SUNDRY NOTICES AND REPORTS ON WELLS
Do not use this form for proposals to drill or to re-enter an abandoned well. Use form 3160-3 (APD) for such proposals.

Apache is requesting permission to Temporary Flare from the Hummingbird Federal South 1 Battery due to Frontier Plant Nitrogen gas issues. Requesting to Temp Flare for 90 days, estimated 980 MCF per day from 06/08/2016 thru 09/08/2016. All flared gas will be metered prior to flaring.

HUMMINGBIRD FEDERAL SOUTH #1 API#30-015-42631
HUMMINGBIRD FEDERAL SOUTH #2 API#30-015-42632

Condition of Approval to Flare Gas

PRELIMINARY
PLAN LAYOUT

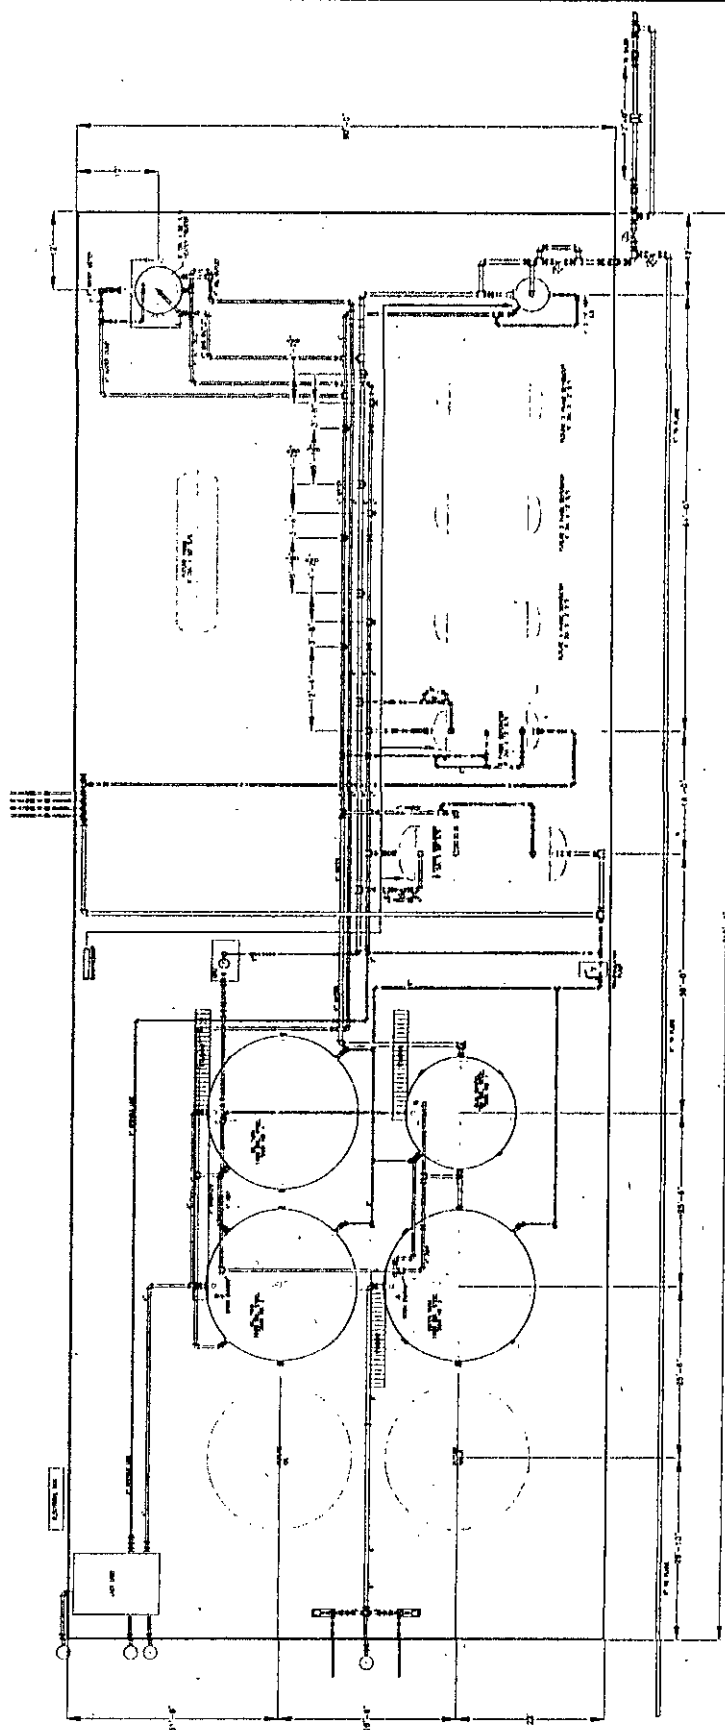
2. See attachment for Flare location diagram
3. Volumes are being reported to the BLM

4. "Avoidably lost" flare volumes shall be metered due to their royalty bearing status. Install gas meter on vent/flare line to measure gas prior to venting/flaring operations if it is not equipped as such at this time.

5. Vent/flare gas metering to meet all requirements for a sales meter as per Federal Regulations, Onshore Order #5 and NTL 2008-01. Include meter serial number on sundry (form 3160-5).

6. This approval does not authorize any additional surface disturbance.
7. An updated facility diagram is required within 60 days of modifications to existing facilities per Onshore Order #3.
